LAFORUCHE PARISH FIRE DISTRICT NO. 3

**HURRICANE IDA DAMAGE RESTORATION
EAST GALLIANO FIRE STATION NO. 8 RESTORATION
HURRICANE IDA RECOVERY NUMBER: HIR-EG08
FEMA DI-NUMBER: 1209198
GALLIANO, LAFOURCHE PARISH, LOUISIANA**

ADDENDUM NO. 2

Date Issued: September 7, 2022

Plan Sheet 07 – Roof Pictures

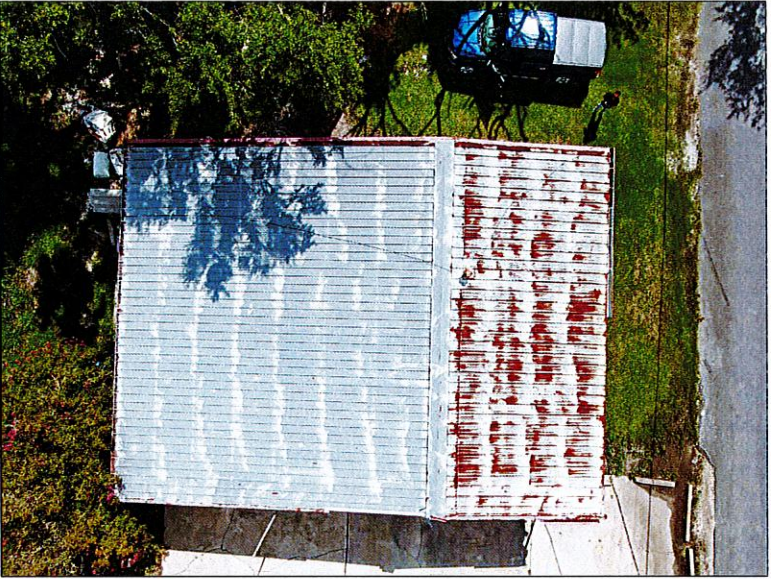
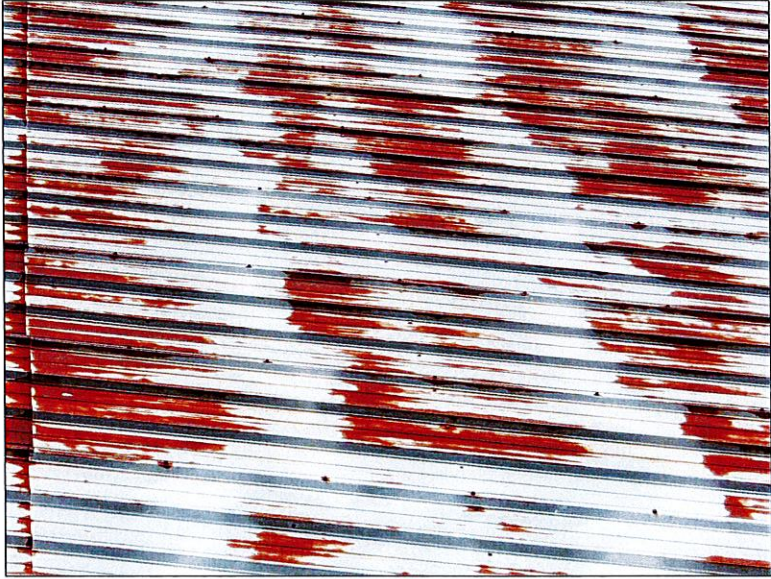
1 = REVISED NOTES AND ADDED PHOTO OF DAMAGED PRIMARY ROOF.

1. Plan Sheet 06 Roof Plan
 - a. Please replace with revised Plan Set 06 provided in this Addendum.
2. Plan Sheet 07 Roof Pictures
 - a. Please replace with revised Plan Set 07 provided in this Addendum.
